ORIGINATION FORM

Proposed Revisions to a Standard Plans Index

Index Number: 700-040

Index Title: Cantilever Sign Structure

SHEET
1 of 5

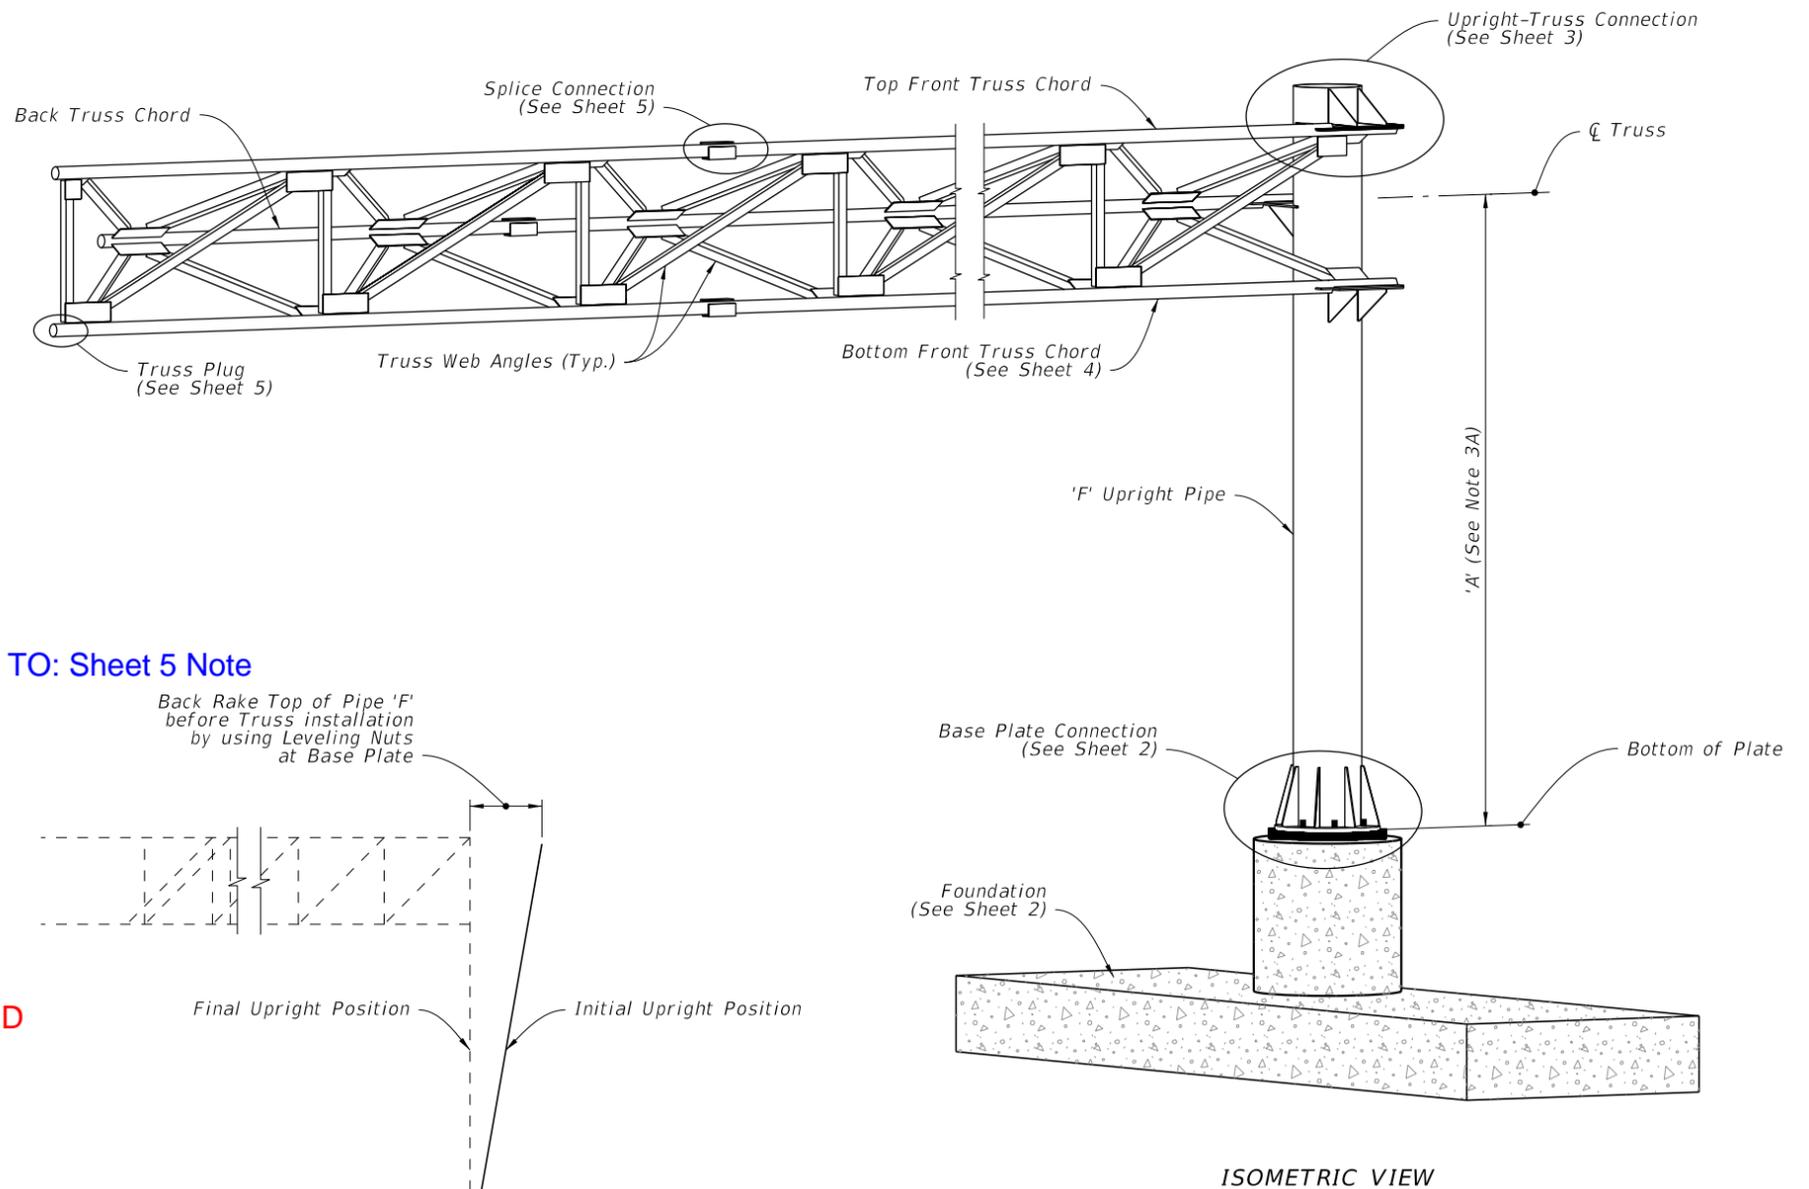
Sheet 1: Updated Notes to General Notes; Added New General Note 1 - "Meet the requirements of Specification 700."; Deleted Notes 4 through 7; Moved Note 5.B to Sheet 5 Notes; Renumbered Notes.

UPDATED: GENERAL NOTES:

ADDED NEW NOTE 1: Meet the requirements of Specification 700.

~~4. Materials:~~

DELETED

~~5. Fabrication:~~

MOVED TO: Sheet 5 Note

~~6. Coatings:~~

DELETED

~~7. Construction:~~

GENERAL COMMENT: Some material, construction, and fabrication information was deleted. Information is either already covered in Standard Specifications OR will be added to Section 700, 962 or 965 in conjunction with these revisions.

FOUNDATION **BASE PLATE CONNECTION**

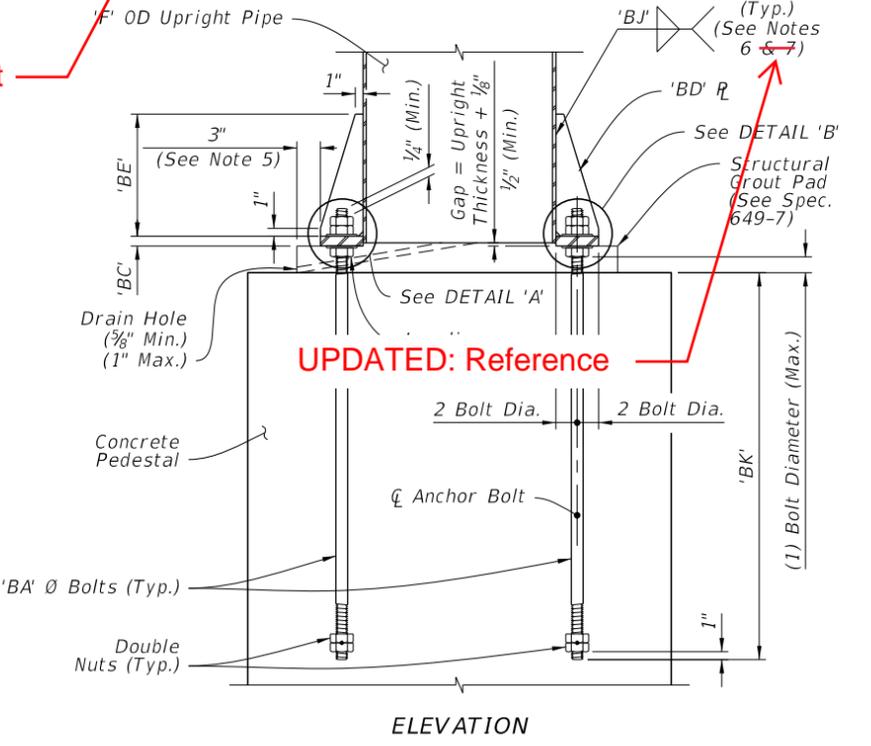
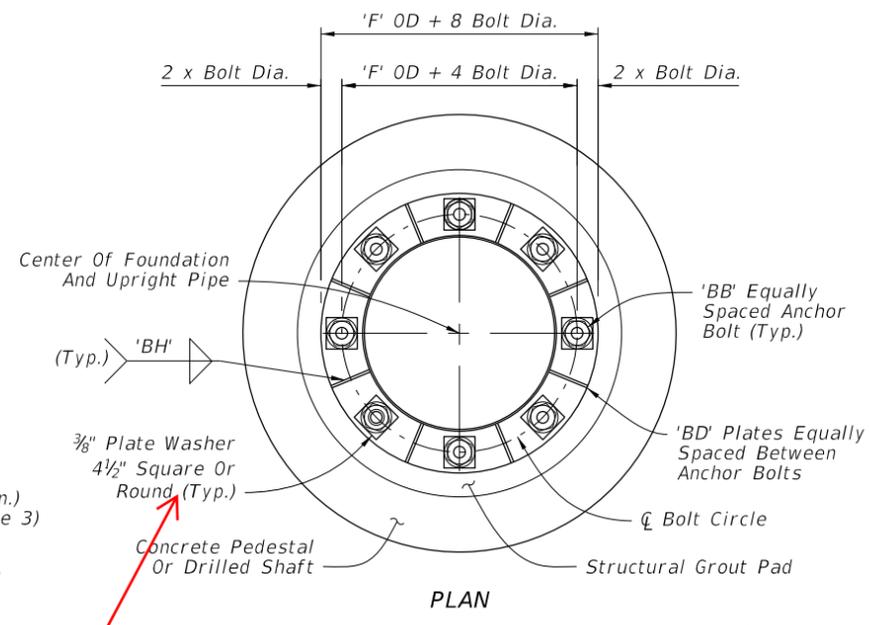
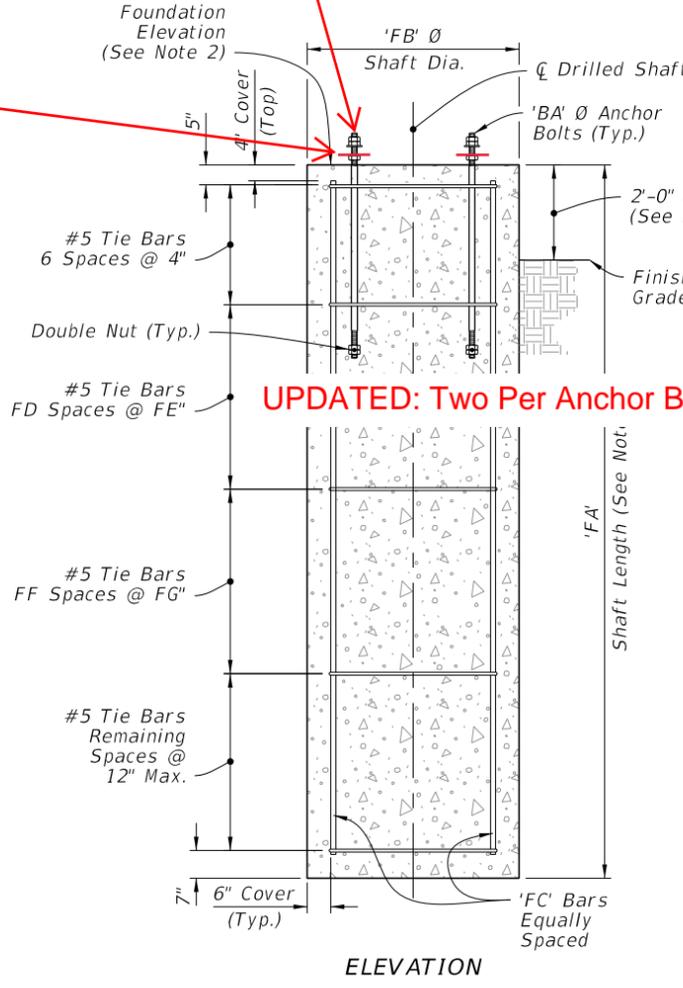
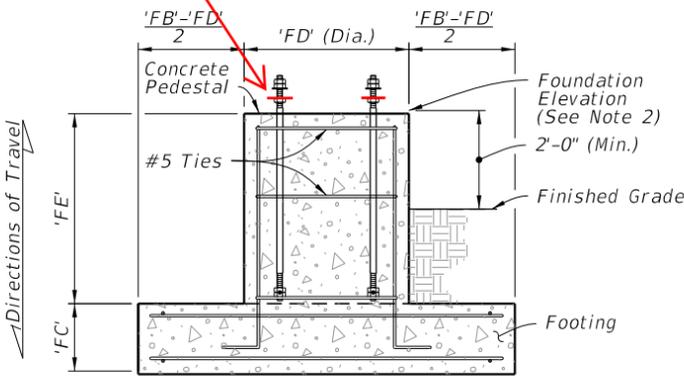
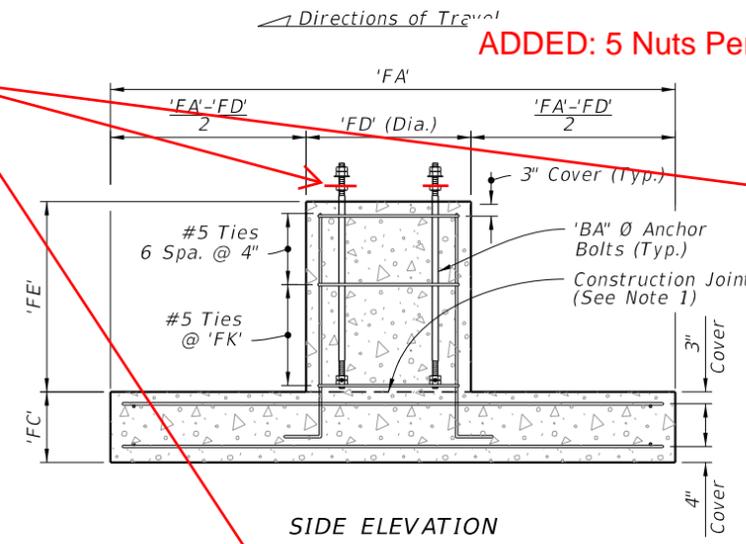
Sheet 2: Deleted Note 7 ; Added Plate Washers to the Anchor Bolts and new callout "5 Nuts Per Anchor Bolt (Typ.)"; in the FOUNDATION details; Updated the Plate Washer callout and the weld references in the BASE PLATE CONNECTION details.

ADDED: Washers

ADDED: 5 Nuts Per Anchor Bolt (Typ.)

UPDATED: Two Per Anchor Bolt

UPDATED: Reference

DELETED

SPLICE CONNECTION DETAIL

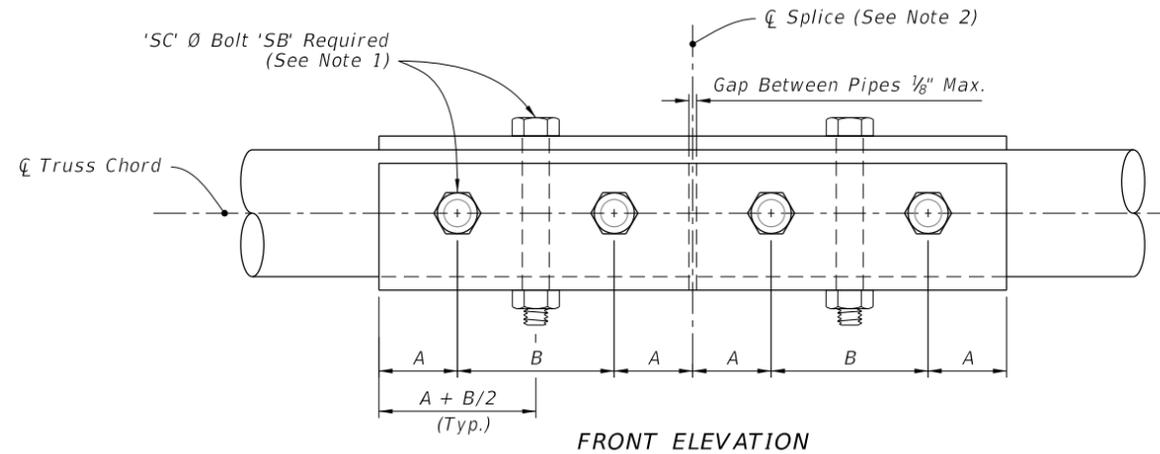
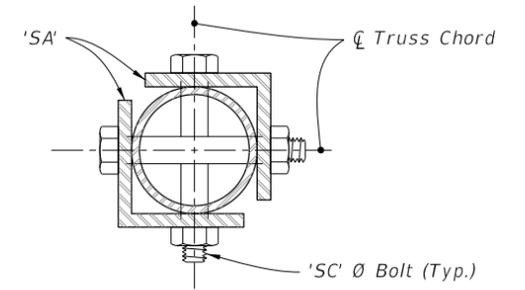
Sheet 5: Added General Note 5.B as New Note 3 - "Chord Splices: "SD" Panel from upright is the closest panel in which chord splice may be used. See Plans for CANTILEVER SIGN STRUCTURE DATA TABLE. Minimum splice spacing is two truss panel lengths apart."

ADDED NOTE 3:
 Chord Splices: "SD" Panel from upright is the closest panel in which chord splice may be used. See Plans for CANTILEVER SIGN STRUCTURE DATA TABLE. Minimum splice spacing is two truss panel lengths apart

1. Only 6 bolts are shown in detail for clarity. (One Half Each Side Of Splice)
2. Splices are not permitted for trusses less than or equal to 40', Splice optional for trusses greater than 40'.
3. Chord Splices: "SD" Panel from upright is the closest panel in which a chord splice may be used. See Plans for CANTILEVER SIGN STRUCTURE DATA TABLE. Minimum splice spacing is two truss panel lengths apart.
